PRODUCT/PROCESS CHANGE NOTICE (PCN)

PCN #: **SG0703-04** DATE: **April 2, 2007**

PCN Type: Audio Codec Top Mark Format Change

Example: **STAC9205X5NBE B2X** The PCN details data location only, chip outline is not to scale and actual device marking is not in color.

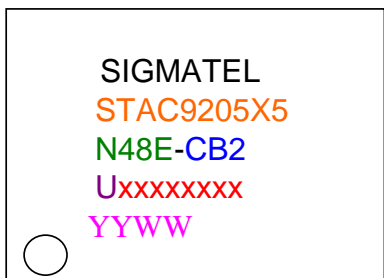
Detail of Change All 48L QFN Audio Codec devices will use the IDT standard top mark format.
There is no change to device design, process or technology.

Line 1: Replaced SIGMATEL name with IDT name

Line 2: Part number line, no change

Line 3: IDT package codes used instead of SigmaTel

Line 4: Lot code replaced by IDT format.

Line 5: removed date code and is added to the lot code line
